N2832A-01

# Modification Recommended Service Note

## N2832A 13 GHz InfiniiMax III+ Series Probe Amplifier

Serial Numbers: US00000000 / US57270000

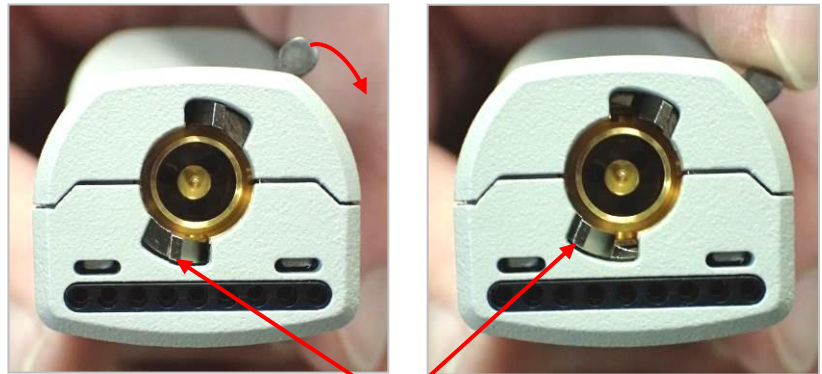
If the set screw is not stainless, it looks like the following after the sticker has been removed:

- a. If the screw is stainless, then remove adhesive and replace the label.
- b. No need to re-calibrate.
- c. If screw is black remove screw using T6 Torx.

Install screw 0515-5534 Tighten T6 to 18 in oz.

**BNC tab rotates with BNC latch rotation**

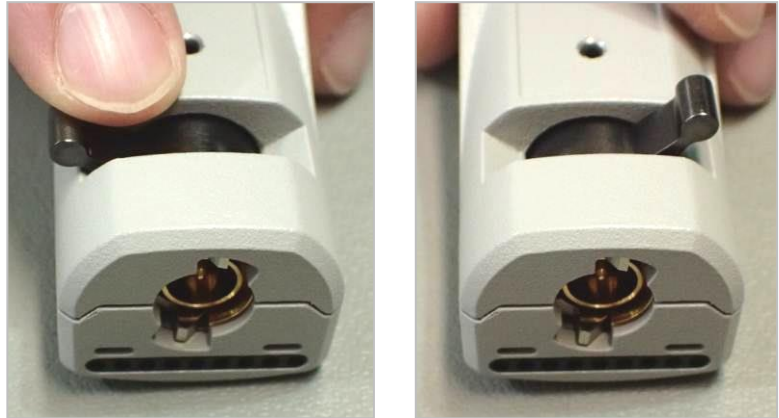
Test the BNC connector by rotating the wing latch **clockwise**, and verify the BNC tab rotates inside the pod housing.

Rotate the BNC wing latch all the way **counterclockwise**. Release the latch to verify the BNC tab rotates back to its original position.
